PCN: V16-003-497078-0A

Product Change Notice

Implementation of alternate substrate materials, including core, prepreg and soldermask.

Product Family	Material Number
PCI Express to PCI-X Reversible Bridge 256 LBGA, Pb Free	PEX8114-BC13BI G PEX8114-BD13BI G

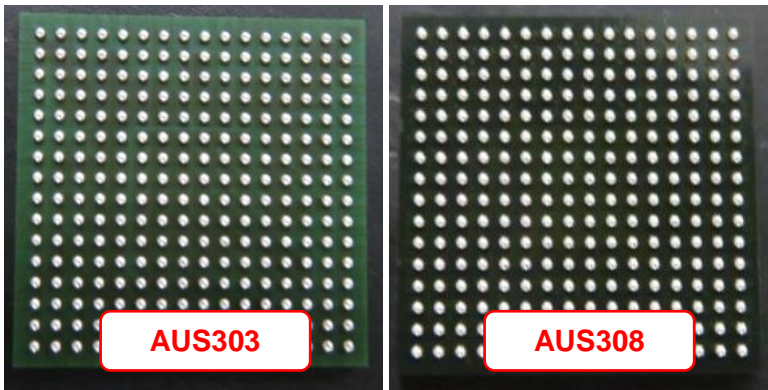
Due to the change from AU3303 to AUS308, the soldermask will have a slightly darker appearance as shown below:
